Subject: Proposal to build a three storied
house on plot No. 3E.sheet G.7 Civil
Lines quarter.

— PROPOSED —
— GUEST HOUSE —
— ON —
— PLOT No 3 E. SHEET C-7 —
— CIVIL LINE QUARTER —
— SCALE 8 FT. 1 INCH —

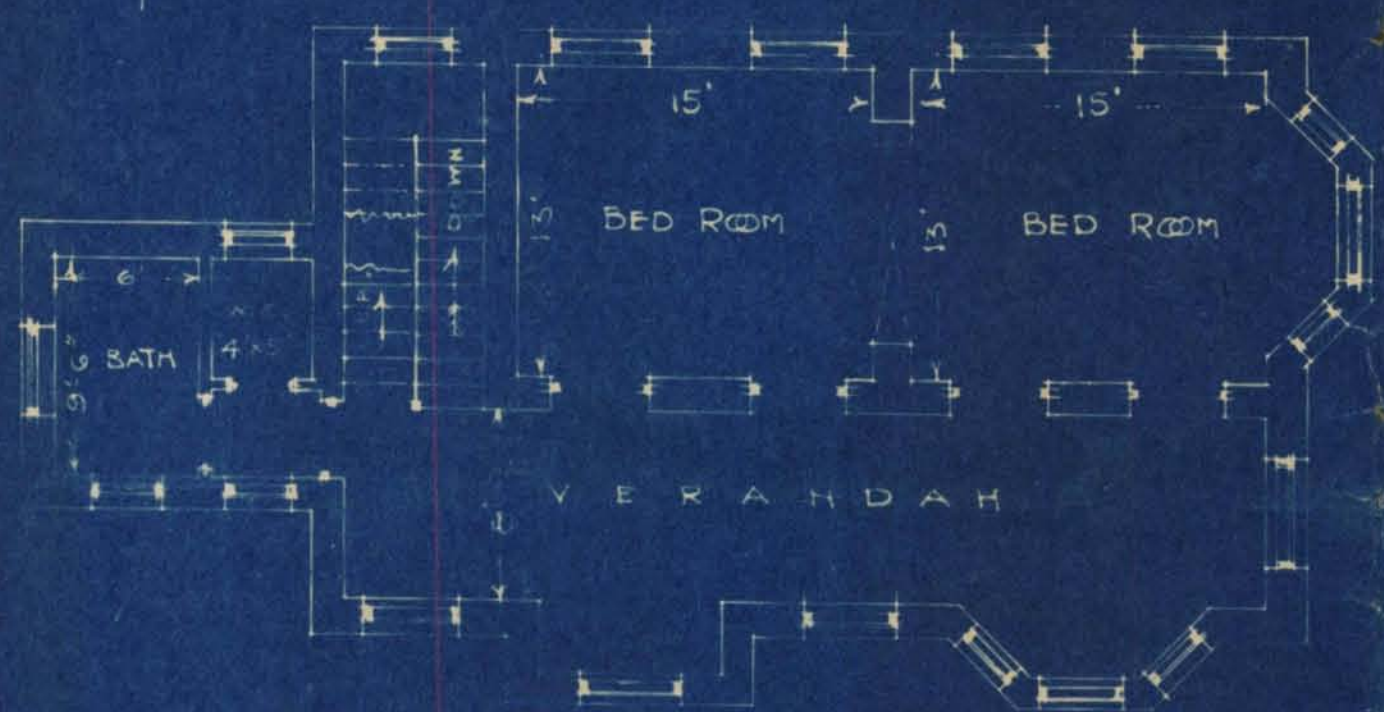
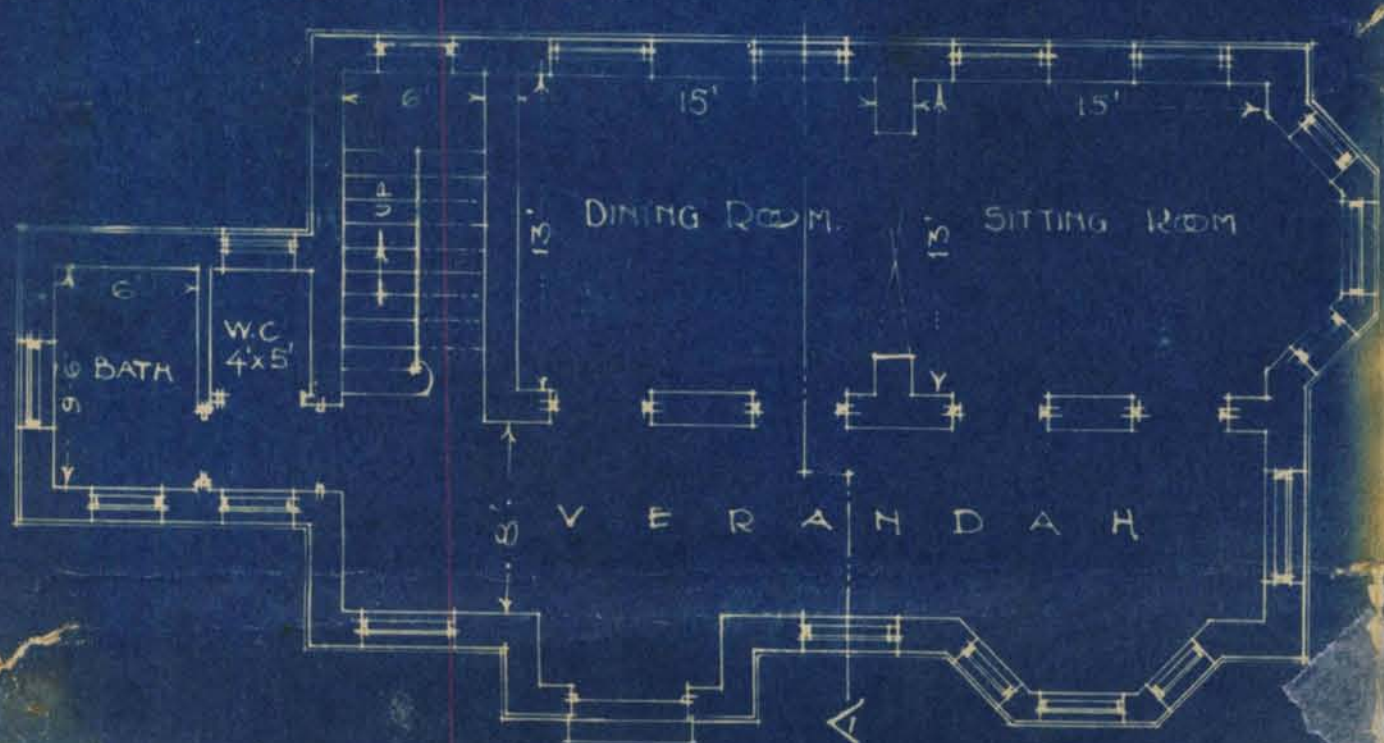
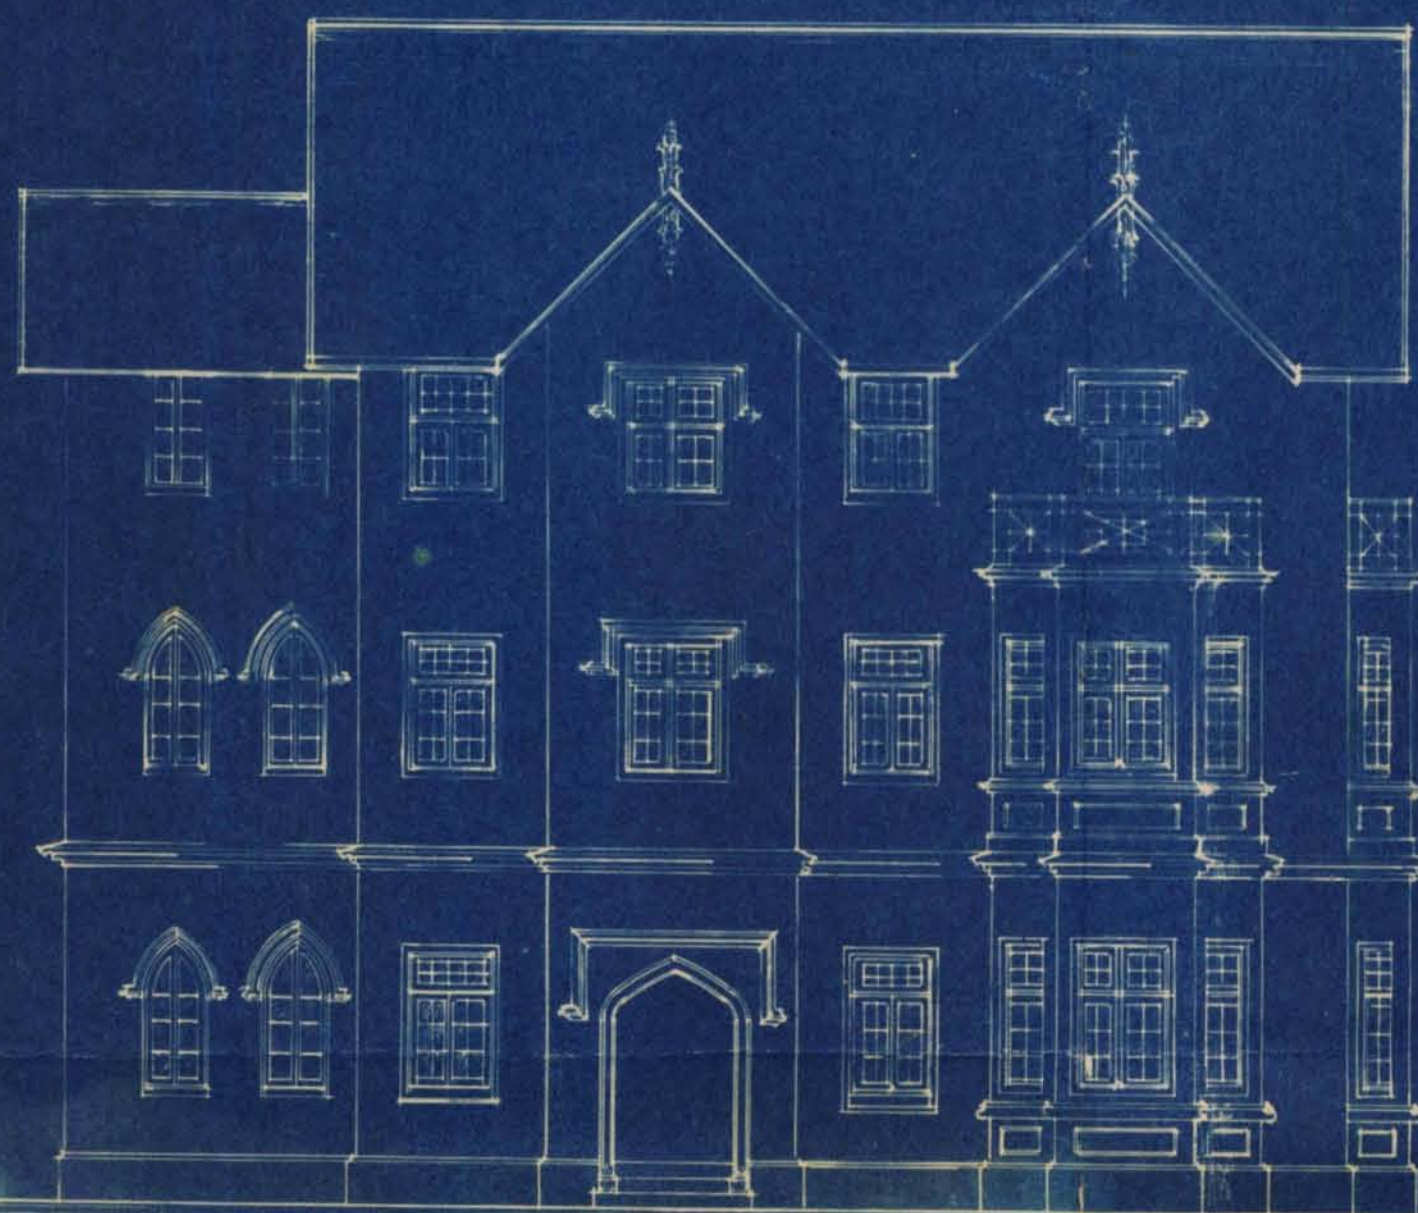
In addition to the objections raised
by you, it seems to me that a three storied building within five
feet of a compound wall cannot possibly be allowed.

- (a) It is not usual to allow two bungalows on one plot in this quarter.
- (b) The existing bungalows along this line stand well back from the road.

In my opinion the proposed three storied structure^{to be} erected in the position shewn on the plan will destroy the amenities of this area which are at present well defined.

With reference to your plans for the proposed guest house on plot No. 3E, G-7 Civil Lines Quarter I have the honour to inform you that if you delete the third storey from the building and set it back 40 feet from the roadway, I am prepared to recommend the Collector of Karachi to pass the plans.

With reference to his application dated 23rd February 1920 with a plan for the proposed guest house on plot No. 3E, G-7 of the quarter Mr. Nusserwanji R. Mehta is informed the plan constitute the building of a second bungalow on the plot.

The building is a three storied one and the site is not suitable for it.

With reference to your application dated 15th
April 1920, I have the honor to inform you that the Collector
of Karachi is not prepared to sanction the plan for the
erection of the proposed building on a Government plot and
the plan therefore is disapproved.

The plan is herewith returned disapproved.

PLAN OF FIRST & SECOND FLOOR

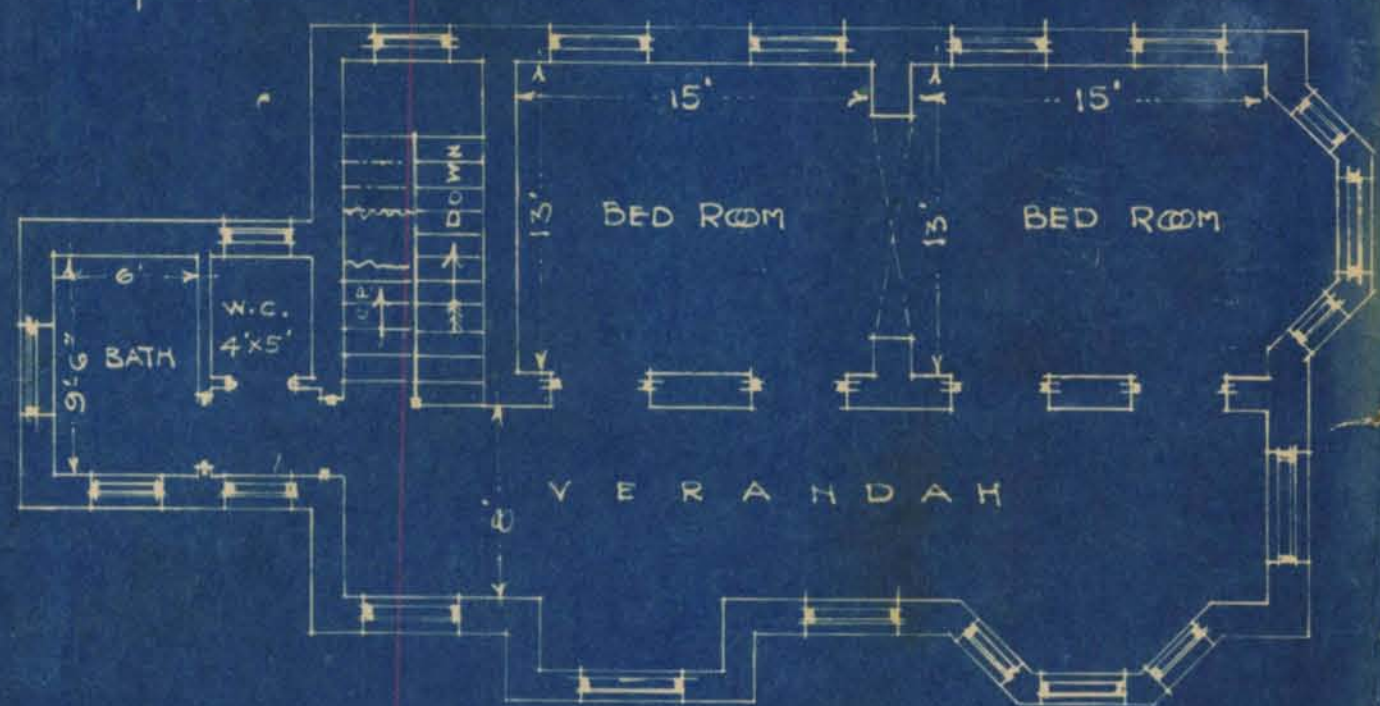
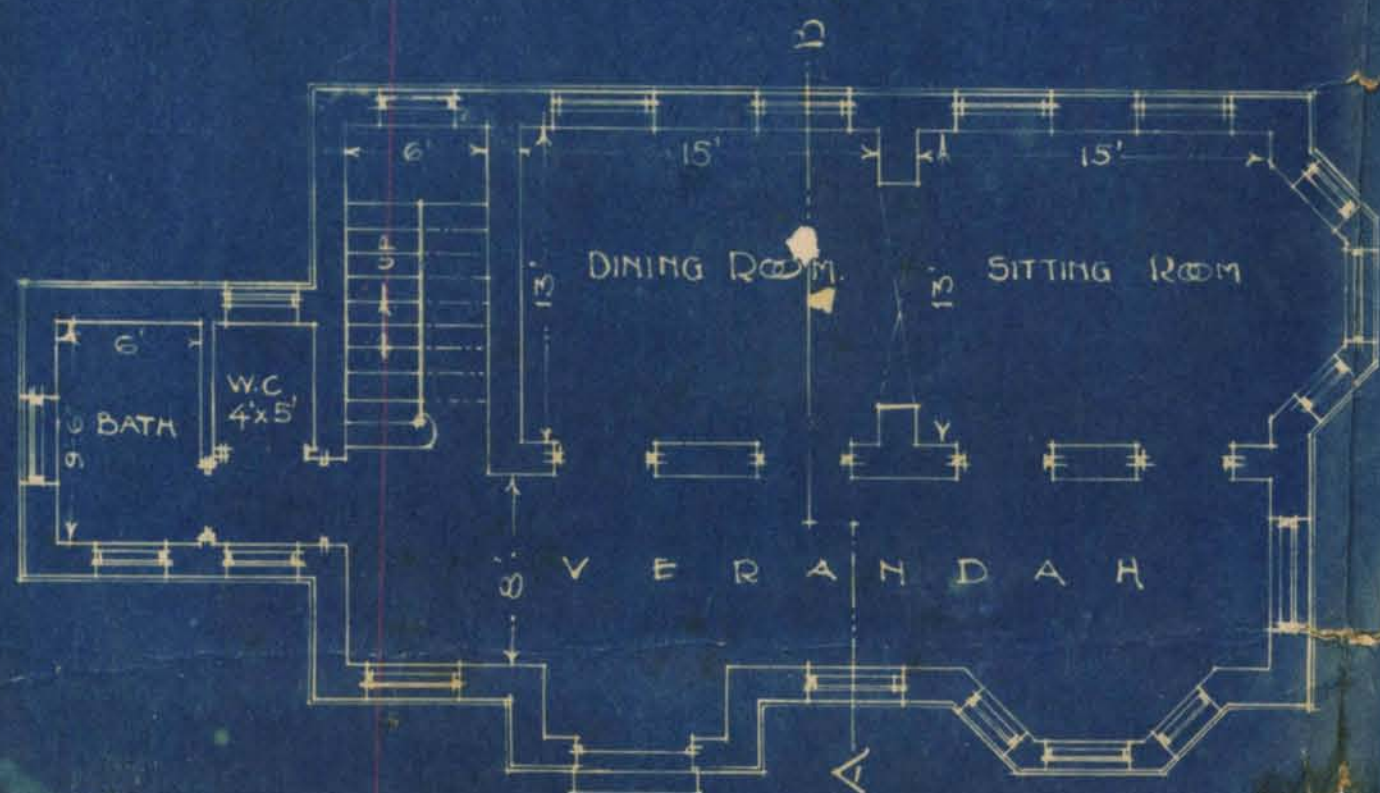
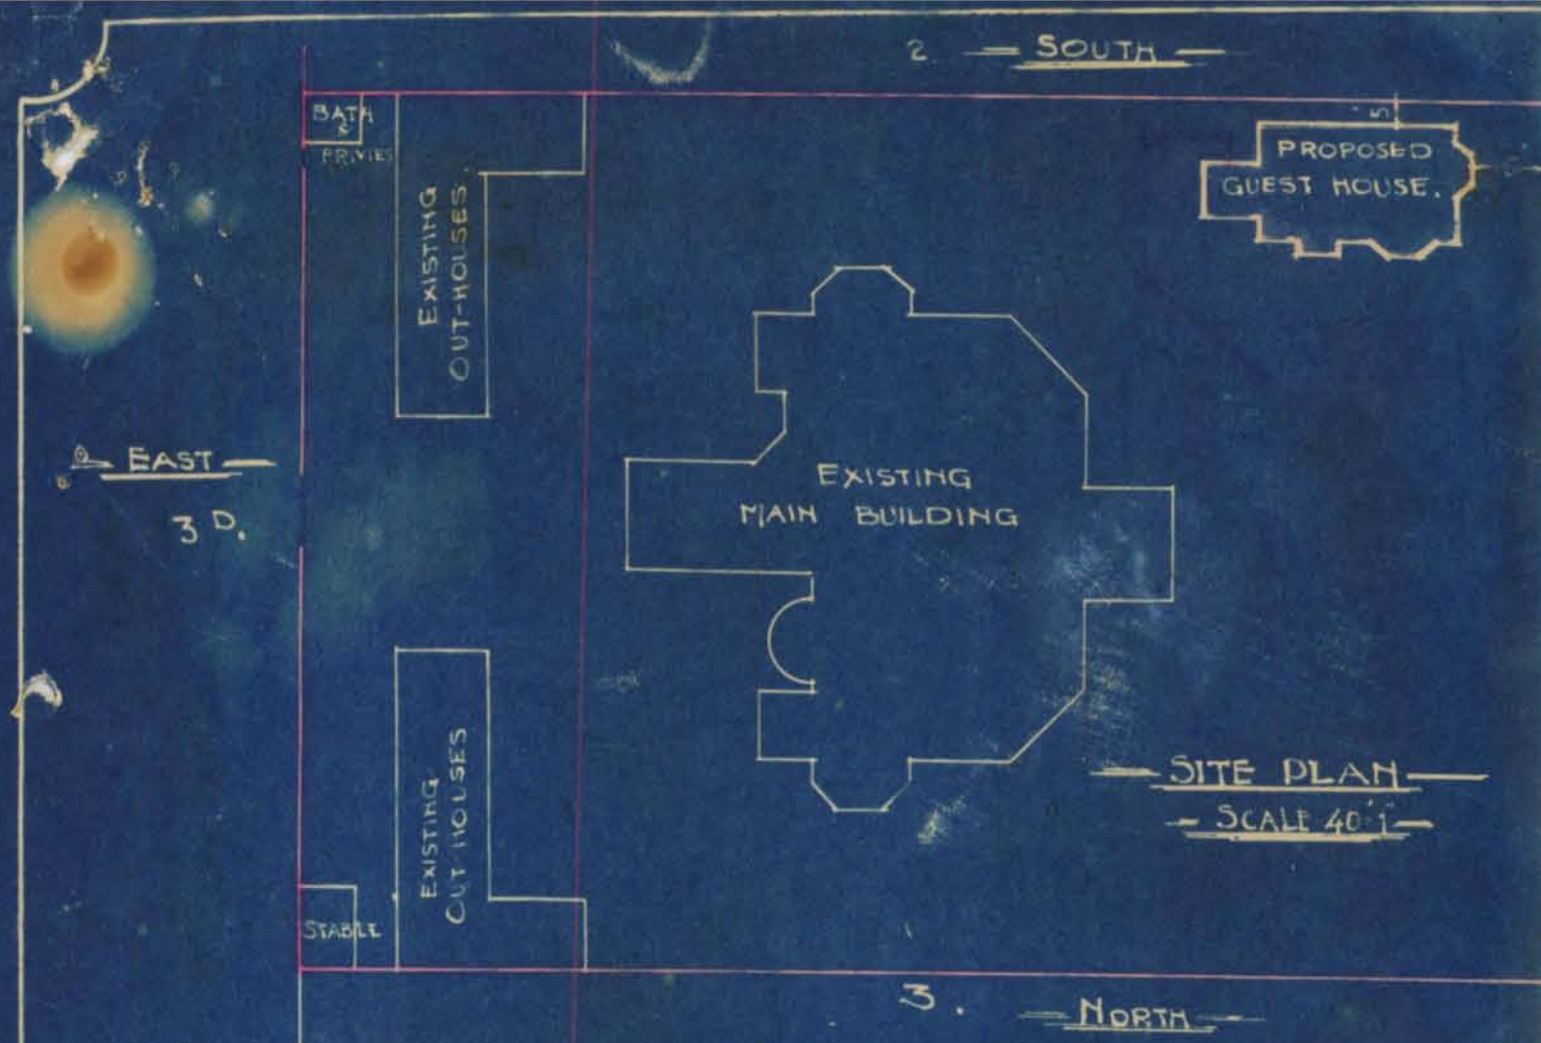
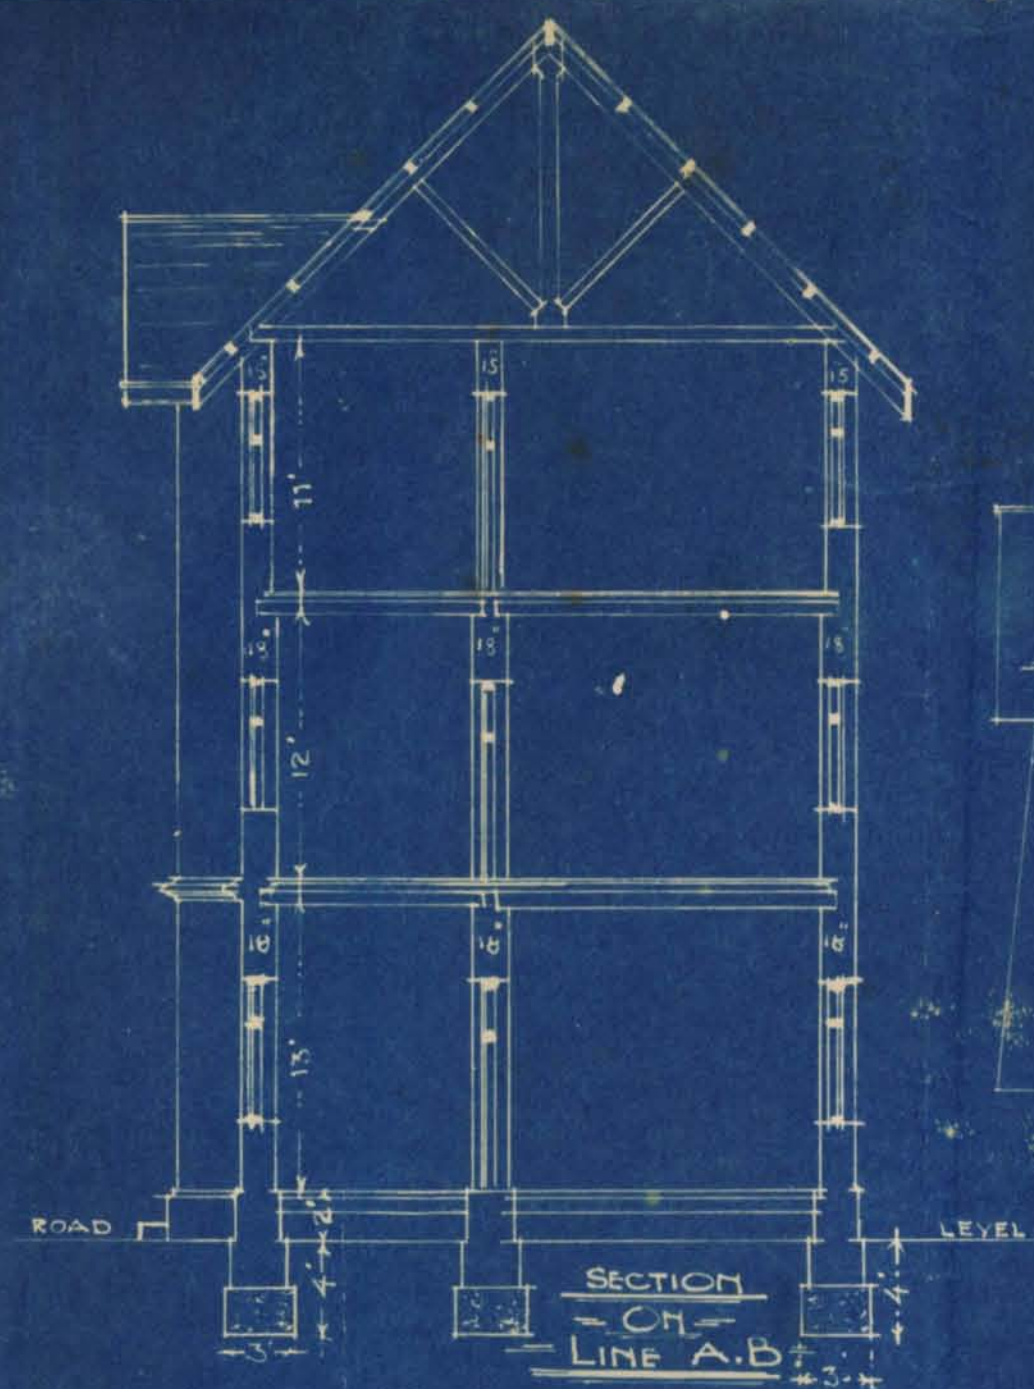
Submitted with $\frac{7}{8}$ report to
owner has removed the the
first house to a 30 ft distance
from the Liphistone Street
instead of 15 ft as shown on
the 1st plan. No further
amendment seems to have
been made in the plan.
Request orders

Submitted for orders. now
the Compound of the proposed
building is too close to the
existing bungalows.

Reply that if he deletes the
third story from the building
and set it back 40 ft from the
roadway I am prepared to
recommend The ~~State~~ Collector
to pass the plans.

The plan constitutes the building for a 2nd building on the plot. The building is a three storied one & the site is not suitable for it.
